**DESCRIPTION OF THE TOTAL SYSTEM  
PERFORMANCE ASSESSMENT  
AND INTEGRATION ISSUE  
RESOLUTION BLUEPRINT**

**U.S. Nuclear Regulatory Commission  
Contract NRC-02-97-009**

**Center for Nuclear Waste Regulatory Analyses  
San Antonio, Texas**

**January 2003**

## Corrosion rates tend to decrease with test duration, why?

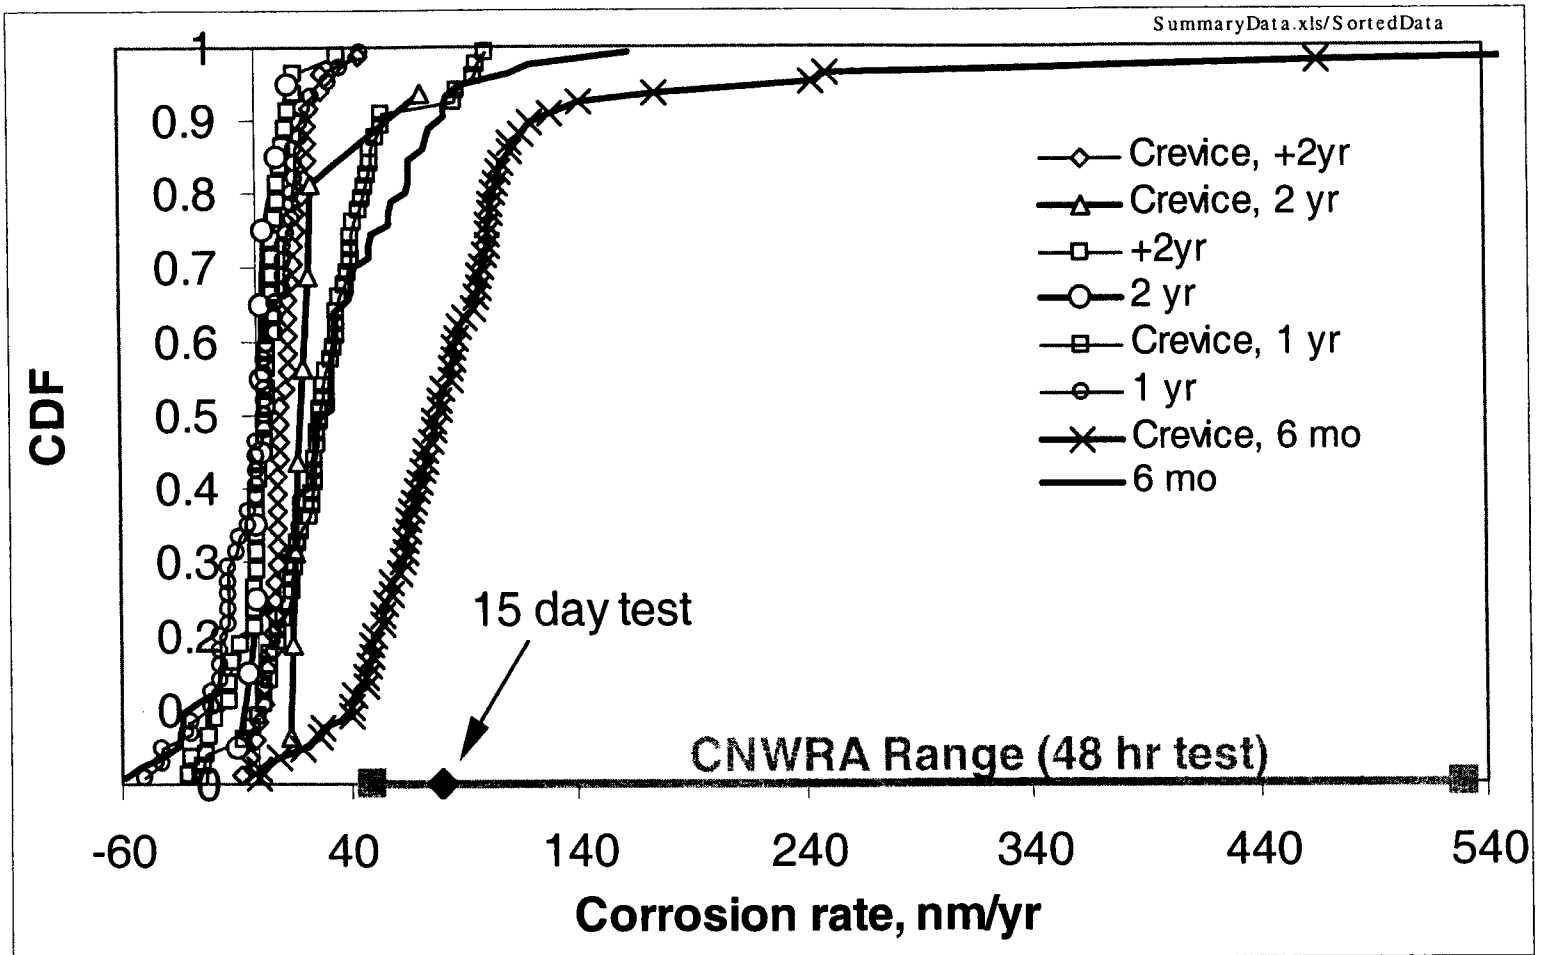
- Only 2 yr test data used in the WP degradation abstraction. Additional justification is necessary to neglect 0.5 yr and 1 yr corrosion rates, specially when such rates are within ranges reported by other authors.
- It was explained that decreasing corrosion rates are expected for alloys having a passive film that thickens with time (WP Deg PMR Rev 00 ICN 02, 2000, p 3-40,41). There is no clear evidence that the passive film on 2 yr samples is thicker than the 0.5 and 1 yr samples. The inner chromium-rich oxide film, responsible for passivity, is likely to achieve steady-state in short time (few weeks), at which time the inner film may maintain a constant thickness. Outer layers in the film are not responsible for passivity.

- Deposition of corrosion products producing “weight gain” may compete with dissolution through the film producing “weight loss,” thus weight loss measurements may underestimate corrosion rates. Deposits have been observed on Alloy 22 under transpassive conditions (Dunn et al., Corrosion 2001, Paper 01125).
- Do silica deposits form an insulating coating? Is it possible that the apparent decrease in the corrosion rate is due to a decrease in the extent of the reactive surface area? Longer term testing tended to yield more samples with weight gain.

# Results

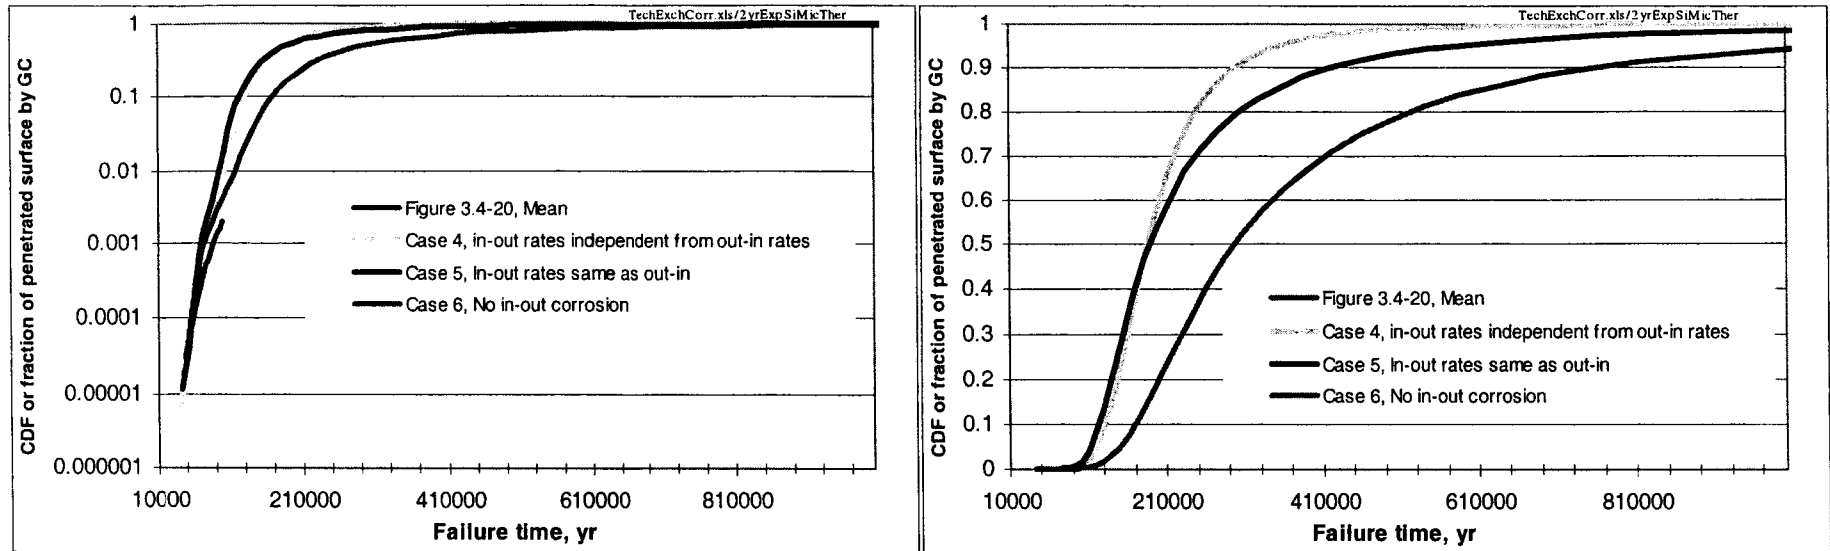
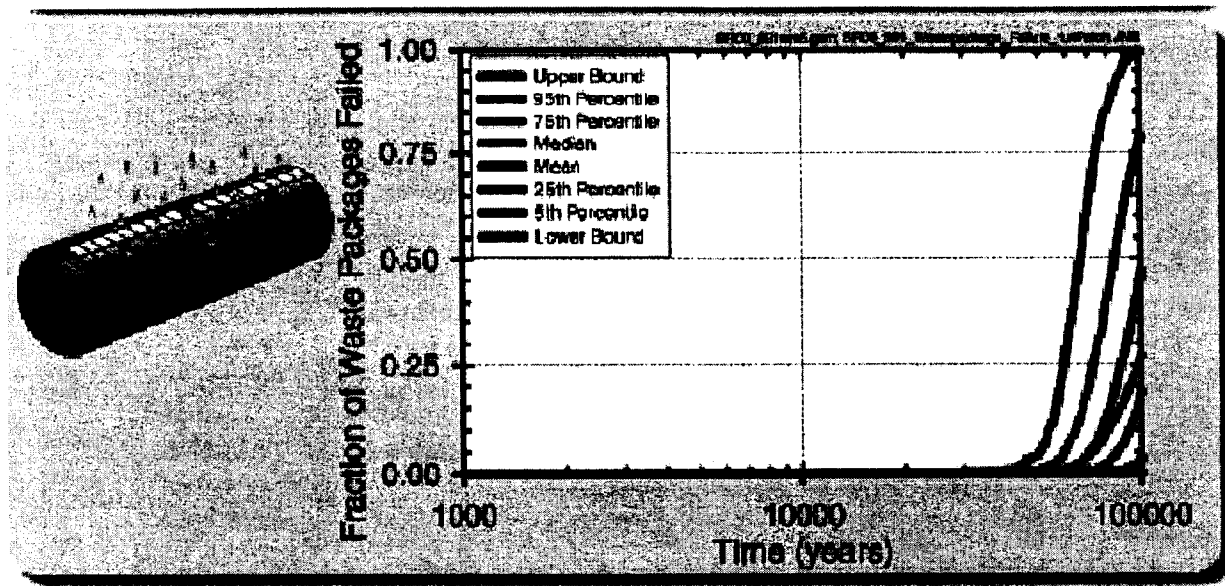
The results seem consistent. Estimates of the fraction of WP surface penetrated by general corrosion are slightly above DOE results reported in the TSPA-SR, p. F3-62, up to a factor of ~10 at 100,000 yr.

Both plots are the same, different vertical scale

Only tails of the CDF are relevant to PA in 100,000 yr computations

Only the magnitude and frequency of high corrosion rates are relevant for PA computations

Figure 3.4-19. Degradation Profiles for Time to First Failure: Drip Shield Patch, Waste Package Crack, Waste Package Patch

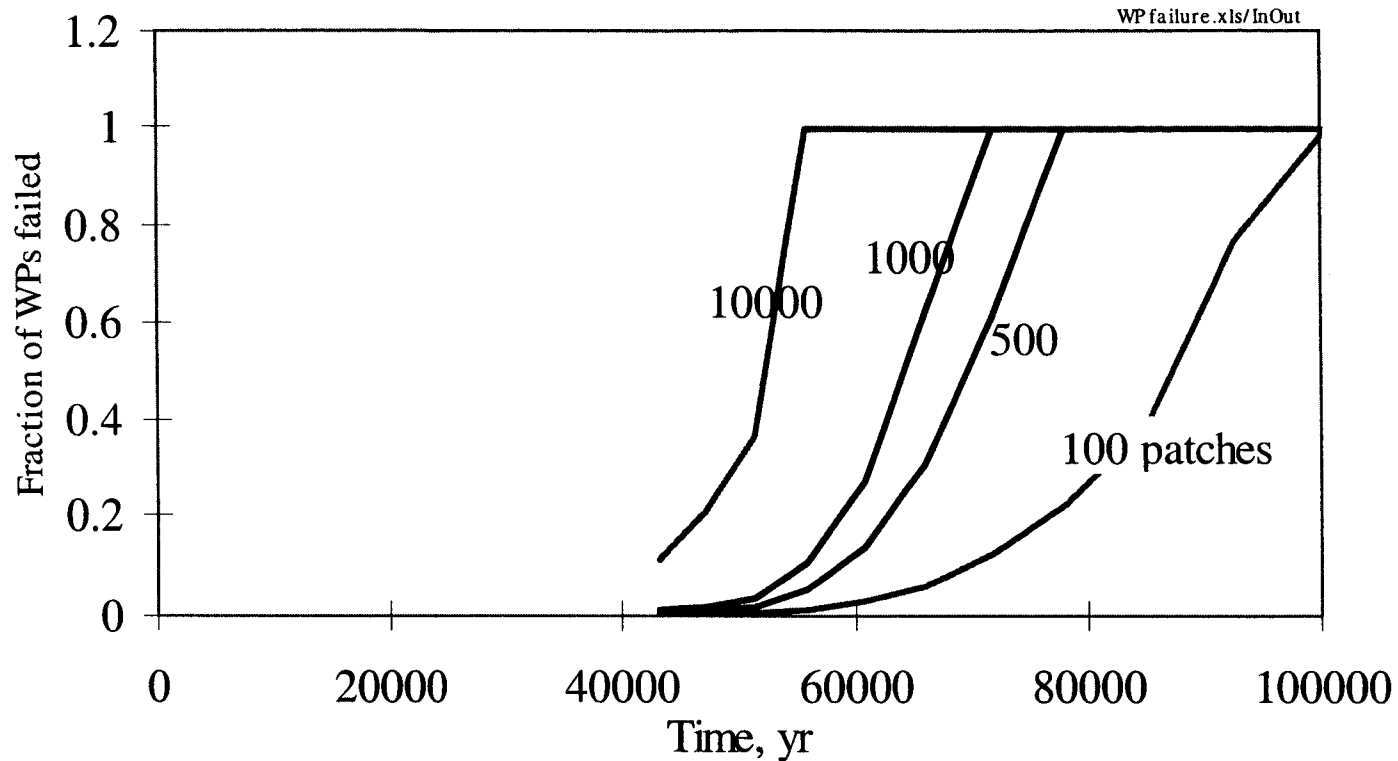
Curves in this figure (from TSPA-SR, TDR-WIS-PA-000001 Rev 00 ICN 01), are not well-defined.

The fraction of WPs failed (1st patch penetration) is an ill-defined quantity. It depends on the number of assumed patches on the WP surface.
